To: T10 Technical Committee  
 From: Rob Elliott, HP (elliott@hp.com)  
 Date: 27 May 2002  
 Subject: T10/02-198r1 SAS OOB timing

### **Overview**

The OOB timing requirements need to be more precise, listing the transmit burst time and specifying receiver tolerances.

**Figure 1. Phy reset sequence OOB signal generation-transmission and detection**

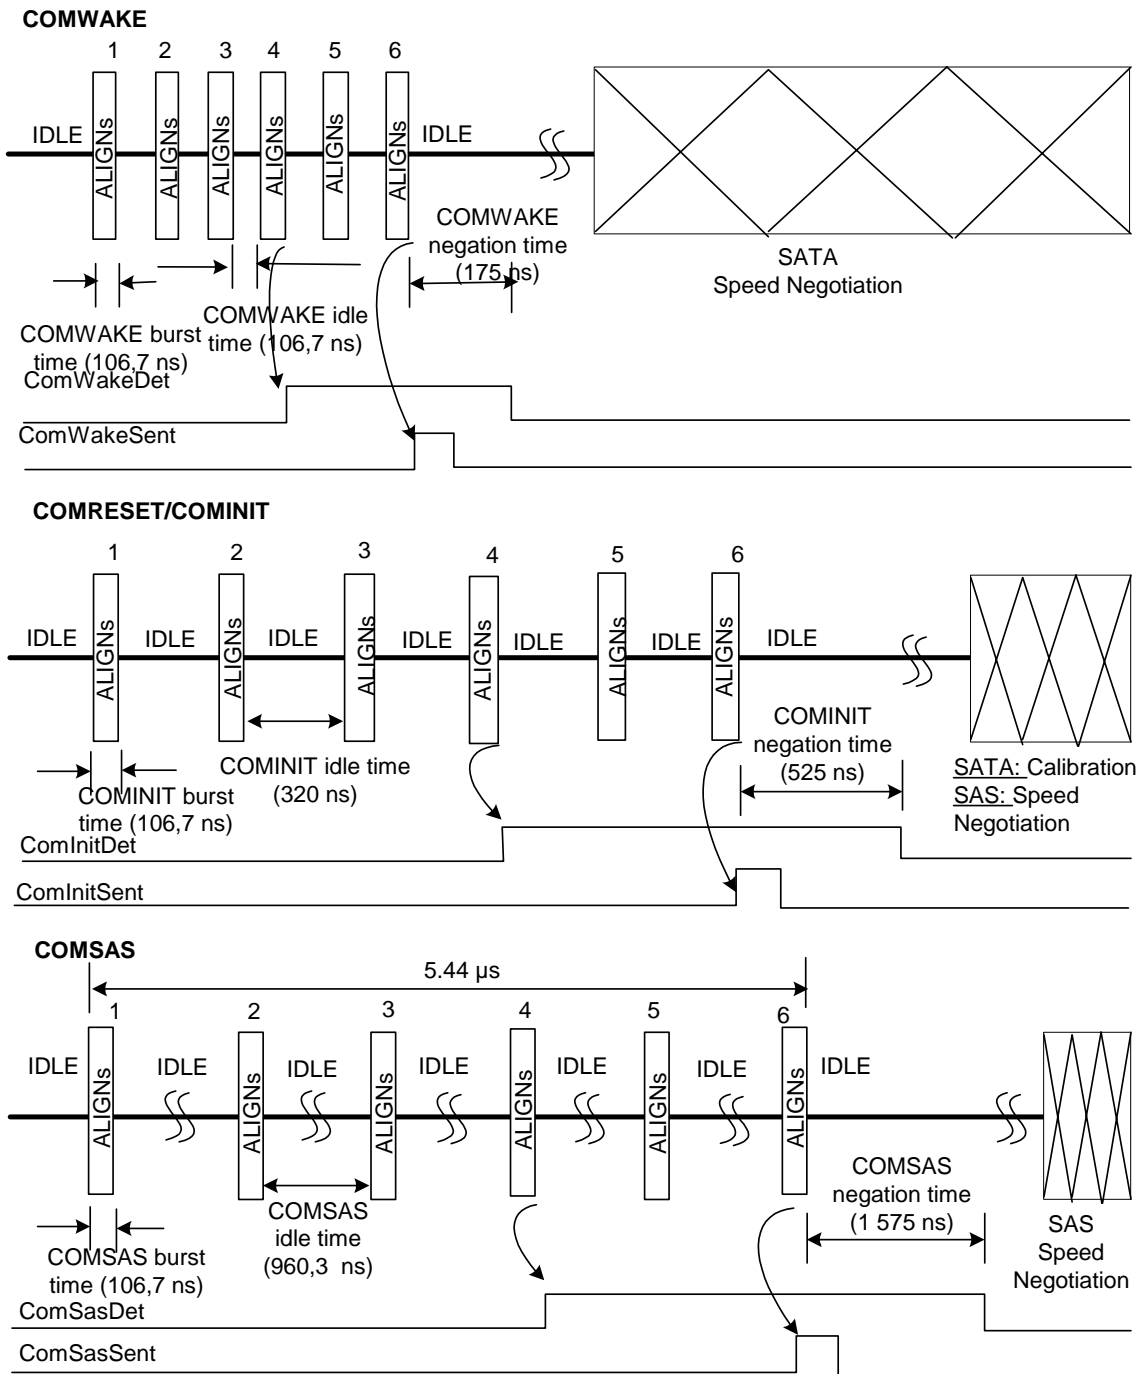
[Editor's note: change all figures to use the (new) acronyms rather than absolute times. If numbers are used, they should be in parenthesis as examples.]

Figure 1 illustrates the timing required for the generation and detection of all the SAS OOB signals. The signals labeled ComXxxDet and ComXxxSent (where Xxx is Wake, Init, or Sas), are inputs to the SAS phy ~~Initialization layer~~ state machine. ComXxxDet is an output from the OOB detection circuitry that indicates the detection of an incoming COMINIT, COMWAKE, or COMSAS ~~sequences signal~~. ComXxxSent is an output from the OOB generation circuitry that indicates that a burst of six COMWAKE, COMINIT, or COMSAS ~~sequences signals~~ has been output onto the link.
